City of  
Richmond

## Report to Development Permit Panel

**File:** DP 22-013200

**Re:** **Application by Oval 1 Holdings Ltd. for a General Compliance Ruling at  
6011 River Road**

-Planter at Tower B lobby entry extended to provide more planting area in arrival court

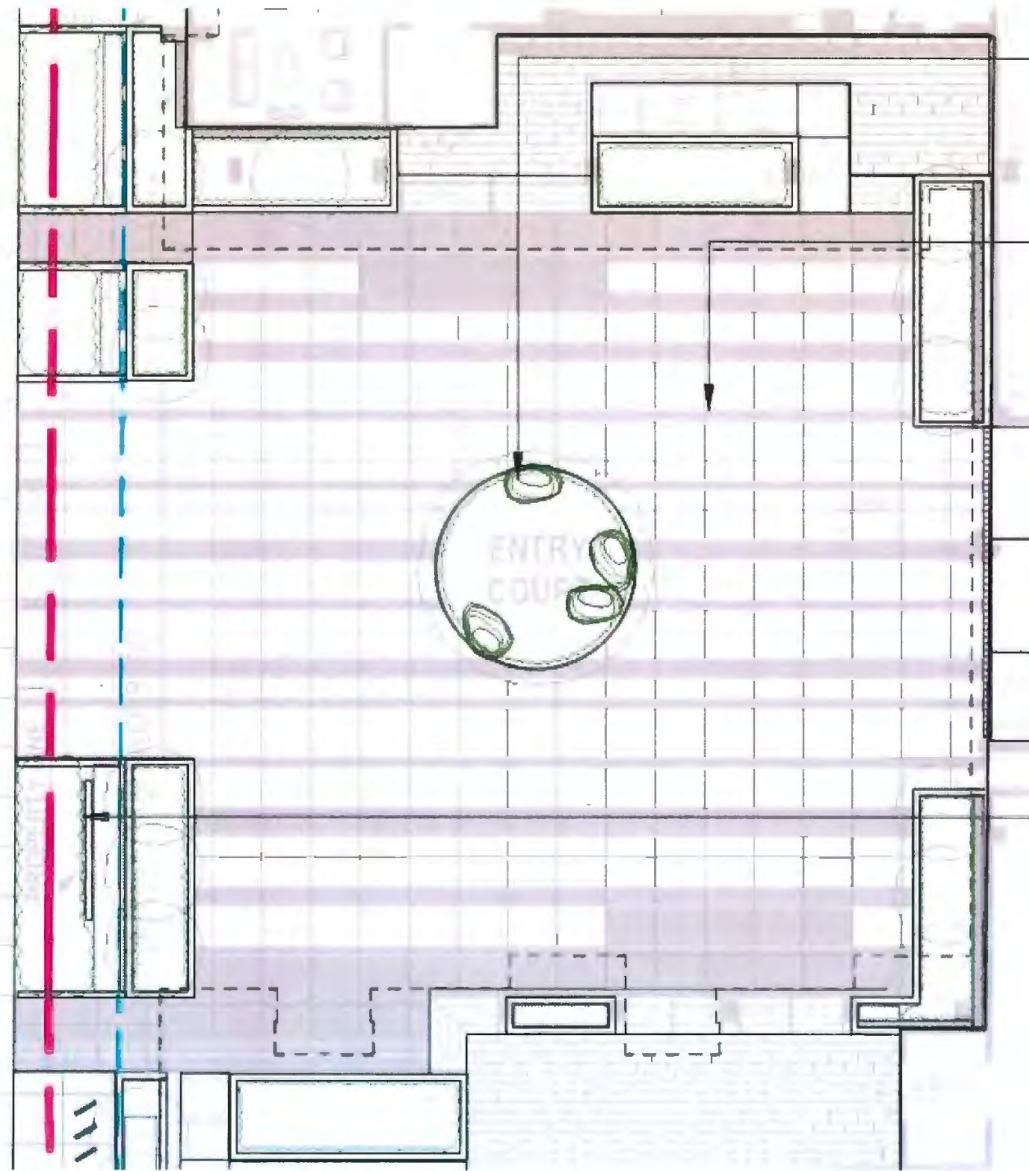
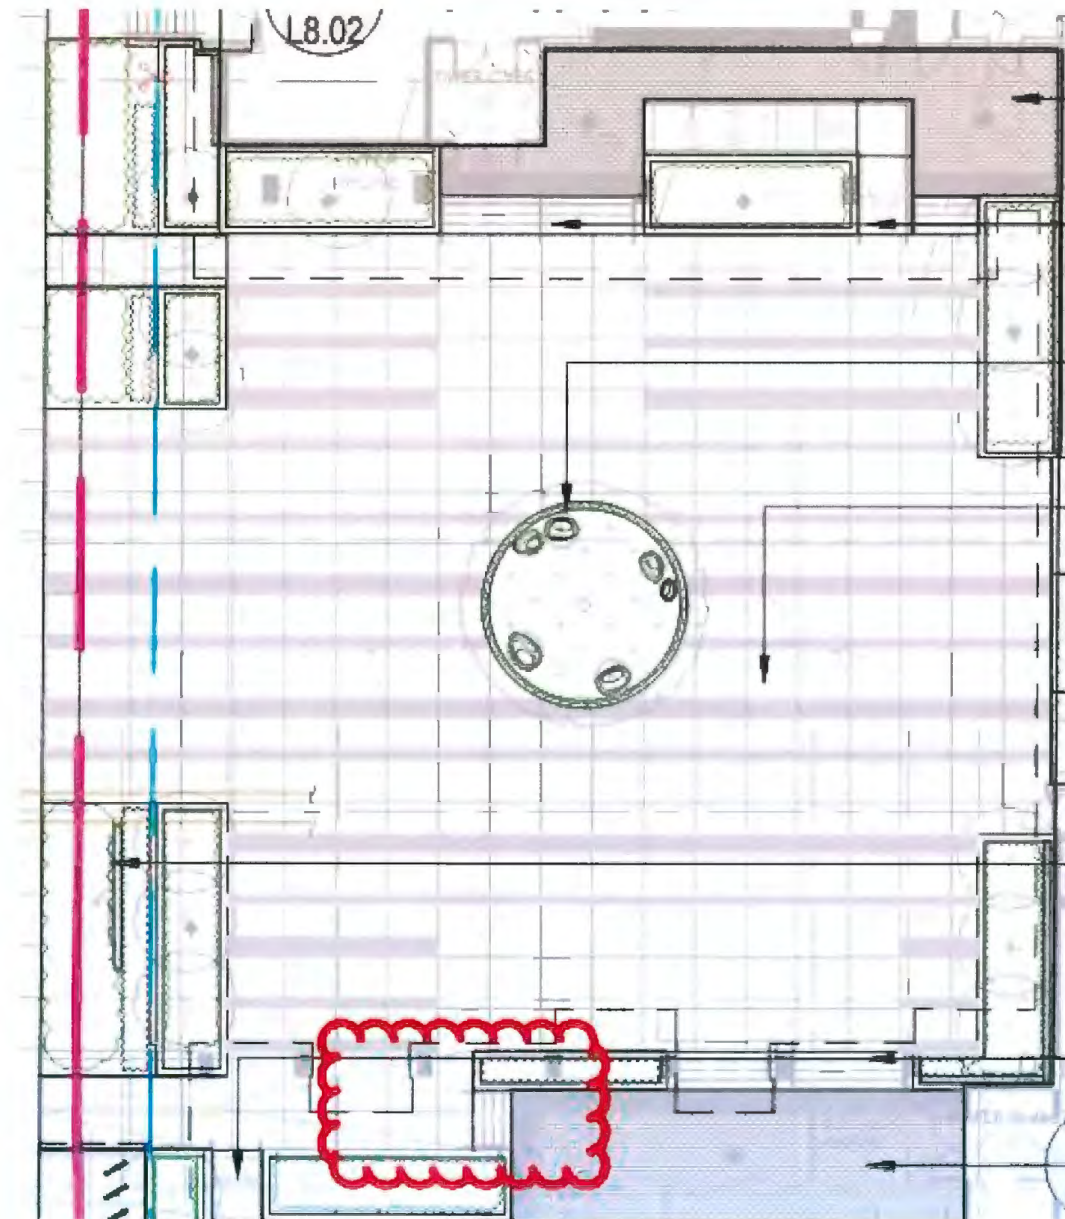
- The planter at the Tower B lobby entry is extended slightly to provide more planting area in the arrival court.
- A private patio planter on Level 2 is extended slightly to ensure sufficient privacy from the common amenity area.
- Planting sizes of some specified trees and plantings were reduced due to local nursery inventory issues.
- The details for the climbing and slide play structure and playhouse, bench, urban agriculture planter, Class B bike rack and BBQ are proposed to be replaced with similar products from a domestic provider with a consistent overall look and design.
- An updated landscape cost estimate confirms no additional landscape security is required to be submitted.

-Improvements to Tower A lobby at-grade planter wall

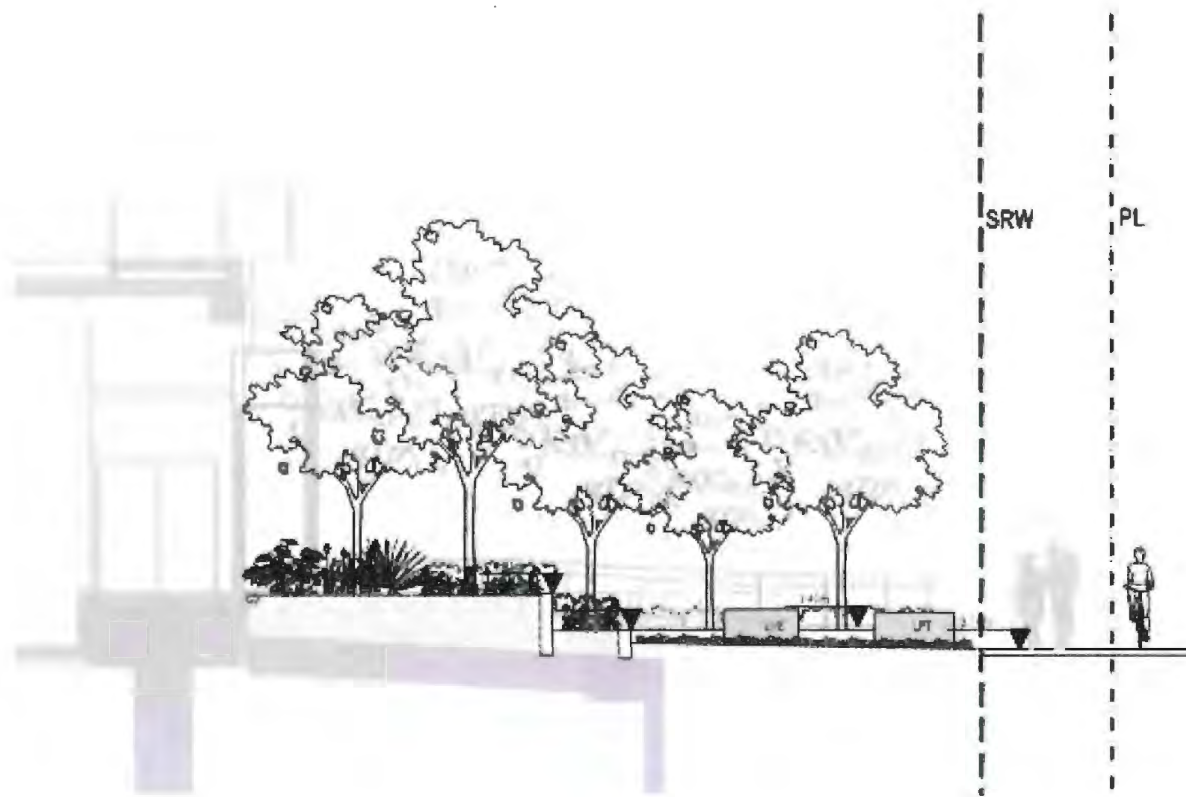
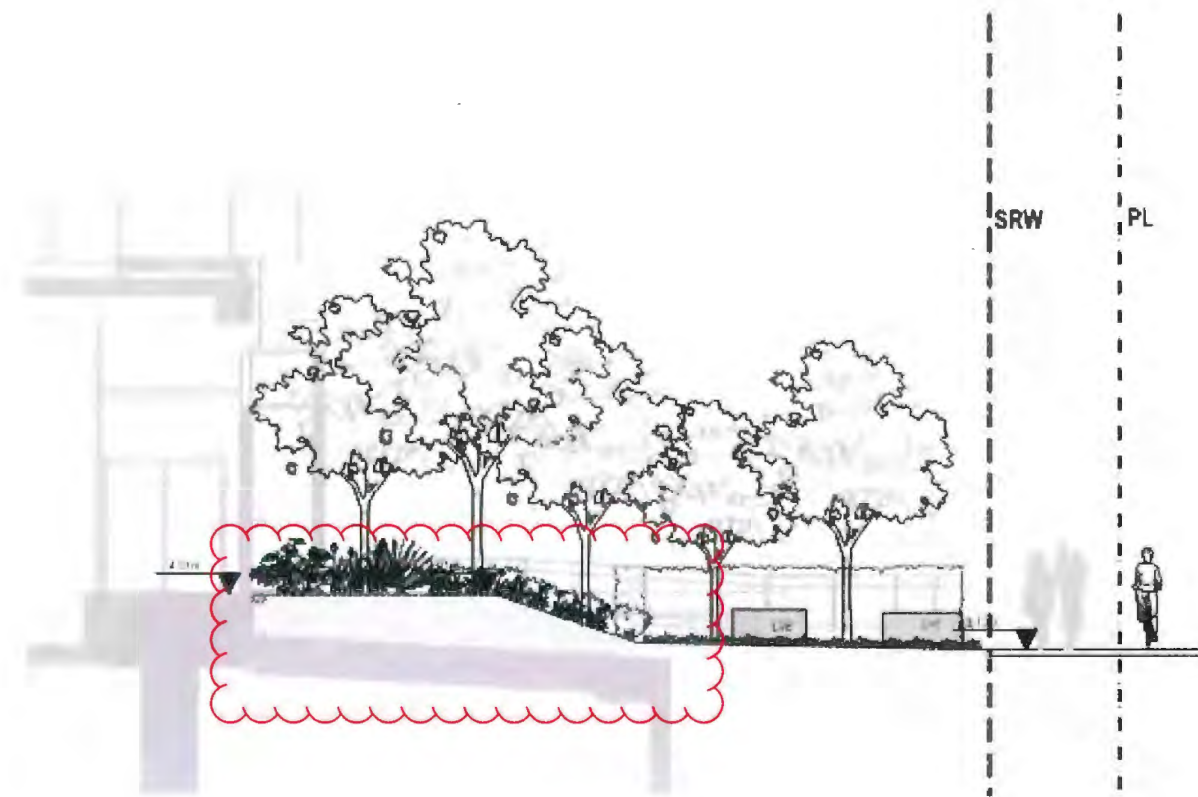
- The applicant is proposing to alter the approved landscaping design between BC Hydro's Pad-Mounted Transformer, the entry ramp and the lobby of Tower A.
- The approved design included stepped retaining walls with plantings to grow and cover the steps. Through a review of site grading, it was determined that the retaining walls are not required.
- The applicant proposes to replace the retaining wall planted area with a gradually sloped landscaping area. This minor alteration will reduce the amount of exposed wall visible to pedestrians.
